CUSTOM DESIGN FOR THE BITTON RESIDENCE

04/11/2012 REVISION 5

FIRST FLOOR

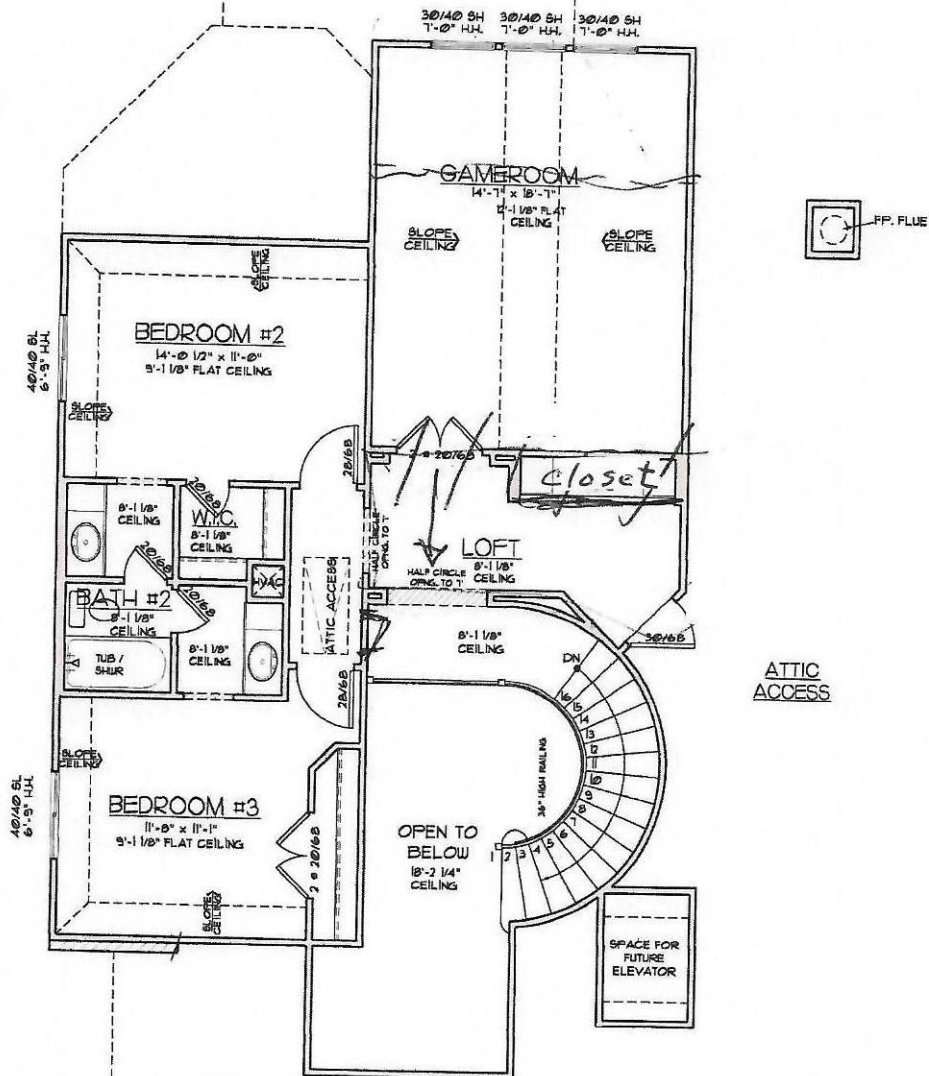
NO SPACE FOR "STANDARD" TUB - NOT ENOUGH ROOM AT SIDES - IF A STANDARD TUB IS TO BE USED (INSTEAD OF CLAW FOOT) I SUGGEST USING ONE OF THE ALTERNATE DESIGNS
